Our Ref: DA6564.1
MSLink/s: 8001
Council Ref: A007038637

Referral Agency Response (Advice)

Transmission Infrastructure Impacted	
Transmission Corridor	Richlands – West Darra (110 kV) Transmission Line Corridor
Easement ID	A on RP113460 (Dealing No. 602416607)
Location Details	
Street address	816 Boundary Road RICHLANDS QLD 4077
Real property description	Lot 1 & 2 on RP83710
Local government area	Brisbane City Council
Application Details	
Proposed development:	Material Change of Use low impact industry, medium impact industry and warehouse
Approval sought	Development Permit

ATTACHMENT 1 – REFERRAL AGENCY (ADVICE) RESPONSE

A SITE PLAN

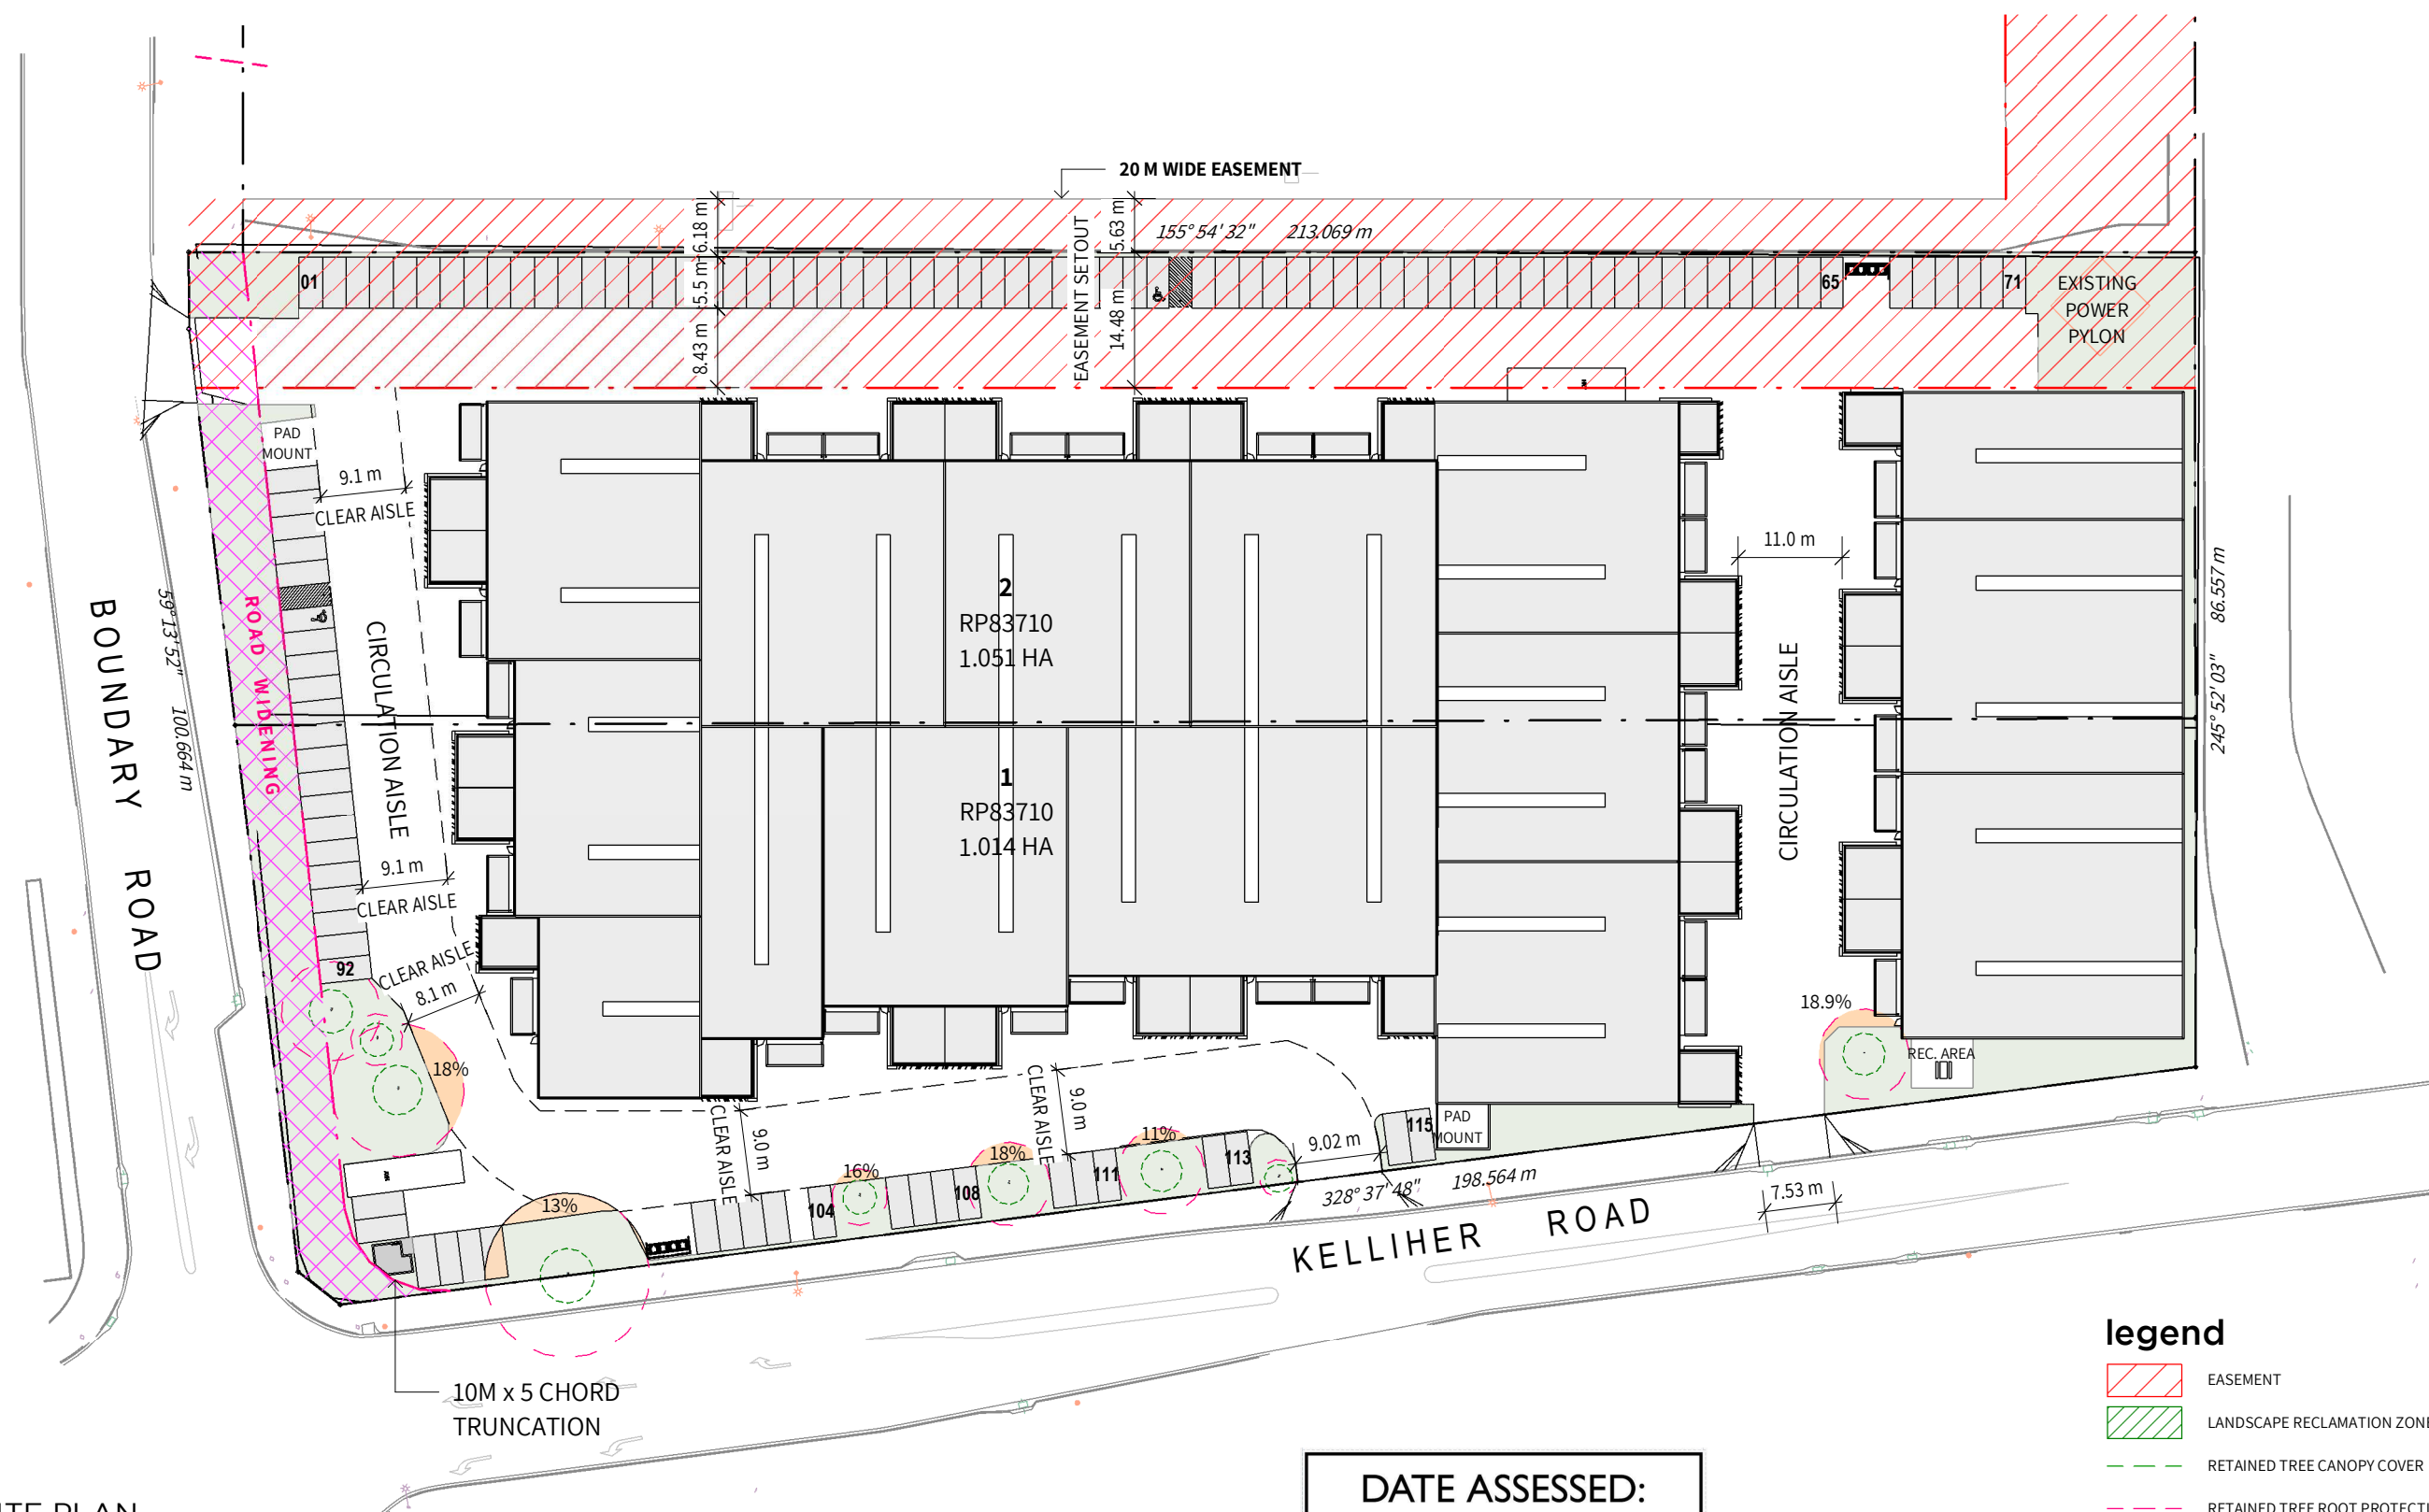
The submitted plans show Tenancy 1.7 and retaining walls (1.2m-2.2m high) located approximately 3.72m and 2.5m from the nearest leg of Tower 1001-STR-0173, respectively. This separation is unacceptable. The proposed location of Tenancy 1.7 and retaining walls would:

The proposed plans show an operational hardstand adjoining the eastern elevation of Tenancies 1.6, 2.12 to 2.17 and 2.1. The warehouse roller doors open directly onto this hardstand, making it a principal loading, unloading and servicing area for the development. The refuse collection area is also located within the transmission easement.

A substantial proportion of the usable hardstand is located beneath the 110 kV transmission lines and within CSA+5m. The proposed layout would therefore direct a range of foreseeable high-risk industrial activities into close proximity to the energised conductors, including:

Relocate the footprint of the affected warehouse building to provide a minimum setback necessary to maintain the statutory conductor clearance. The amended design must demonstrate that the minimum 6.0m -metre horizontal clearance is maintained under maximum conductor blowout conditions. Amended site plans, elevations and cross-sections must be provided to demonstrate compliance.

Remove or relocate tenancy 2.7 and retaining walls so that all buildings, offices, awnings, structures, fences, services and fixed infrastructure are located outside the required 20 metre by 20 metre tower maintenance area associated with Tower 1001-STR-0173. The area made available by removing or relocating the affected tenancy could potentially accommodate the refuse collection area outside the transmission easement, subject to maintaining Powerlink access. The amended plans must clearly show:

Redesign the hardstand and parking layout so that land within the transmission easement is limited to:

Loading and unloading areas, operational hardstand, outdoor storage, stockpiling, bulk-bin collection and areas intended for the operation of lifting equipment or mobile plant must be located outside the transmission easement and CSA+5m. Any parking or vehicle movement area retained within the easement must not encroach upon the tower maintenance area.

3 Stage 02 - Elevation C - East
1: 350 @ A3

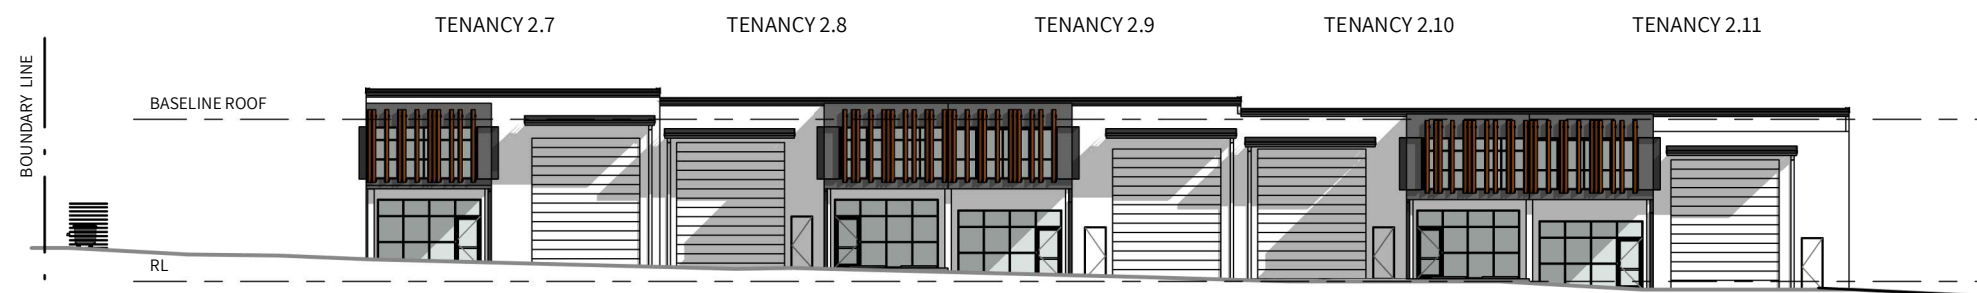
Powerlink's modelling indicates a maximum blowout of 10.1m from the centre line of the relevant span (1011-STR-0173 to 0172). Applying a 6.0m horizontal clearance from the maximum blowout shows that the proposed eastern elevation encroaches the horizontal clearance and is non-compliant with the *Electrical Safety Regulation 2013*. This encroachment represents an unacceptable electrical safety risk and the affected warehouse building and office must be redesigned or set back to comply.
